***ECLIPSE***  
**Engineering Bulletin**  
No: EB-0502

**Product : 9150(9176) DCS/CTCSS MODULE**

**Topic : Firmware Update**

**Date : 14/09/2005**

Top Layer of TX PCB

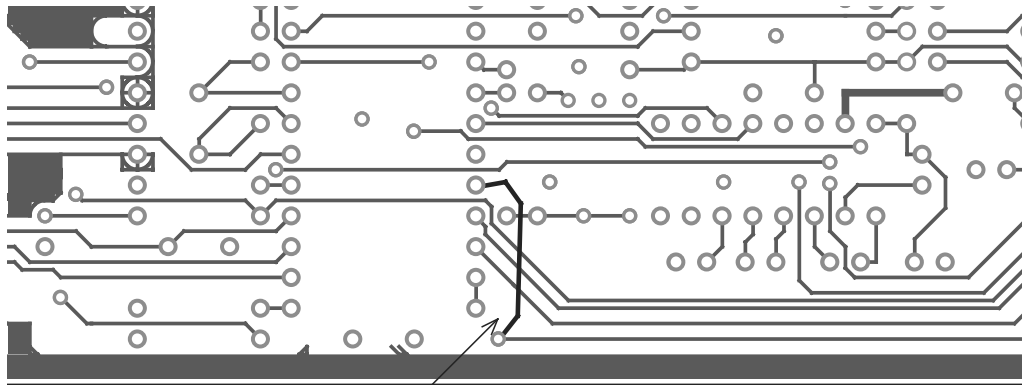
Replace the EPROM with revision 059103V12 (supplied by RF Technology)  
Further modifications on the TX PCB are needed, refer EB0404.

1. Cut the track (schematic diagram net name "reset") as shown.
2. Connect U13 Pin44 (MISO) to the Via hole (pin3 of the sub tone module)

Cut the track here

Connect Via hole to U13 Pin44
